**DECLARATION OF GREGORY ROWANGOULD, PH.D.**

**Review of the Albuquerque Rapid Transit (ART) Project's Potential  
Transportation and Environmental Impacts**

Prepared:  
June 8, 2016

Figure 1 Modeled Change in LOS from No-Build to Build Scenario (blue = increasing LOS, red = decreasing LOS)

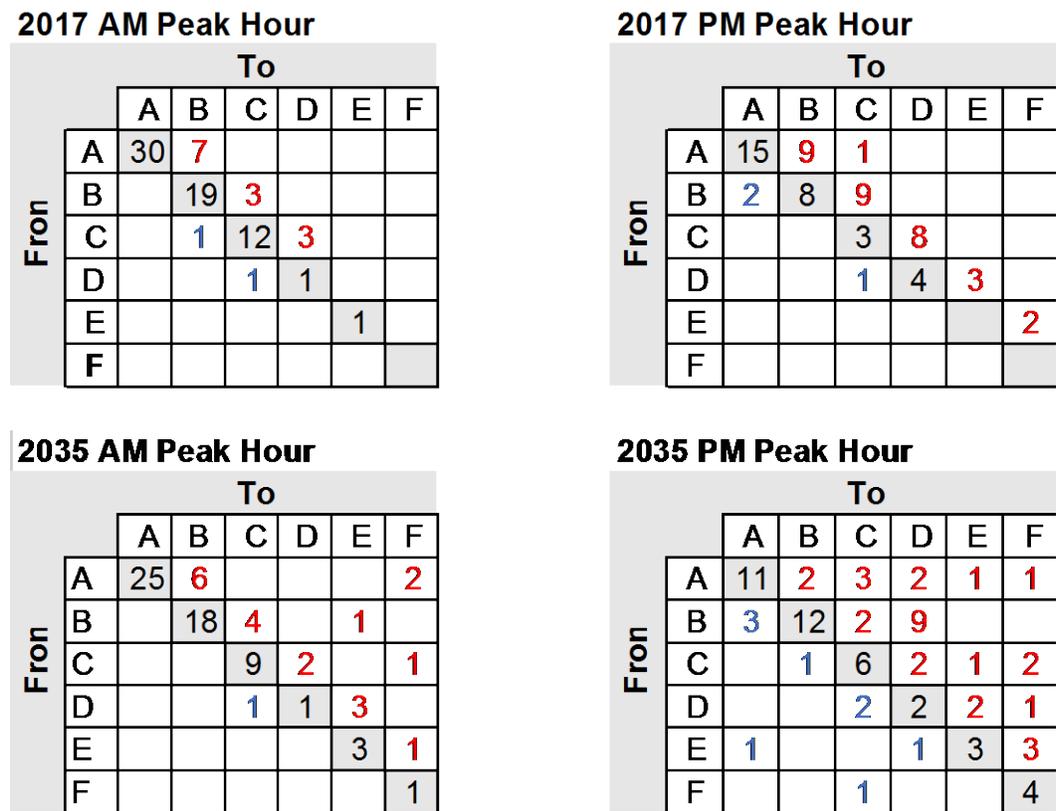
As shown in Figure 1, the traffic study demonstrates that the LOS of a large number of intersections will be degraded, rather than improved, by the ART project in its first year: LOS at

13 intersections will degrade during the AM peak hour and 32 will degrade during the PM peak hour. By the year 2035, intersection LOS in the project area declines for both the build and no-build scenarios because traffic volume is expected to continue growing over 2017 levels. However, the impacts are much worse if the ART is built than if it is not built: 20 intersections during the AM peak hour experience a reduction in LOS and 31 intersections experience reductions during the PM peak. These LOS reductions are also larger than in 2017. For example, in the AM peak period two intersections go from a LOS A without the ART to a LOS F with the ART, meaning that they will have gone from the best possible LOS to the worst. Intersections operating at a LOS of F along a busy corridor such as Central Avenue will likely become significant bottlenecks.

The ABQ Ride traffic study itself indicates that the ART project will significantly increase traffic congestion so it is difficult to understand how ABQ Ride could have answered “no” to this question. The traffic study finds that the ART project would cause deterioration in LOS at 13 intersections during the AM peak hour and 32 during the PM peak hour in its first year of operation. By 2035 intersection LOS in the project area declines for both the build and no-build scenarios because traffic volume is expected to continuing growing over 2017 levels; however, the impacts are much worse if the ART is built: 20 intersections during the AM peak hour experience reduced LOS and 31 intersections during the PM peak. These LOS changes are also larger than in 2017. For example, in the AM peak period two intersections go from LOS A without the ART, but to LOS F with the ART (see Figure 1 of this report).

ABQ Ride implies that there will be few, if any traffic impacts. ABQ Ride summarizes the 2017 results from the traffic study and states that during the AM peak hour *no* intersections will operate worse under the build scenario when compared to the no-build scenario<sup>68</sup>. This is simply untrue. The traffic study indicates that 13 intersections will operate at a lower LOS under the build scenario. This claim is not made for the PM peak where even more intersections will operate at a lower LOS (see Figure 1 of this report).
